Wulfsberg Electronics <i>A Chelton Group Company</i>		TITLE: SERVICE BULLETIN WSB IDU-III-17 (IDU LIMITS DIGITAL GAIN MODIFICATION)	
APPROVALS DRAWN Robert DuRall CHECKED Dean Boston PRODUCT MANAGER	DATE 07/22/05 07/22/05	SIZE A	CAGE CODE 1B7G3
ENGINEER Robert DuRall ISSUED Vern Wallace	07/22/05 07/25/05	DWG NO. 150-045036	REV A
Typed signatures indicate approval. Handwritten signature approval of this document is on file at Wulfsberg Electronics, Prescott, Arizona.		SCALE: NONE	DO NOT SCALE DRAWING

SERVICE BULLETIN

EQUIPMENT: IDU-III

BULLETIN NUMBER: WSB IDU-III-17 Revision A

Figure 3 System User Programmed Settings (Page 1)

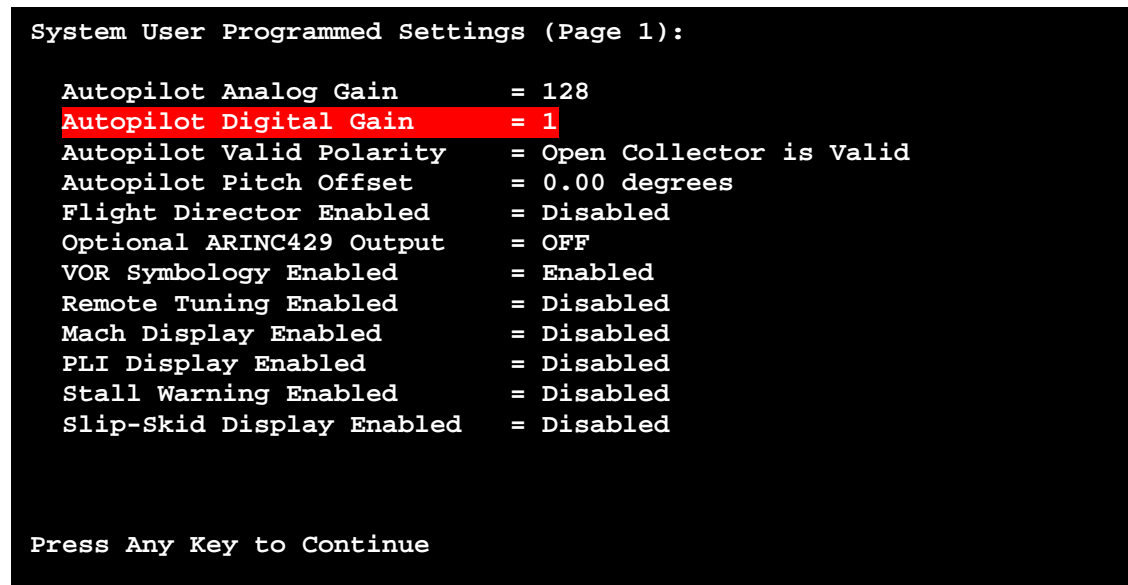
6. Press any button or rotate the right-hand encoder three (3) times until the “System User Programmed Settings (Page 1)” is displayed.
7. View the *Autopilot Digital Gain* option (As shown in red in Figure 3).

8. If the *Autopilot Digital Gain* option displays a value other than “1”, proceed with the Modification Procedure in this Service Bulletin.
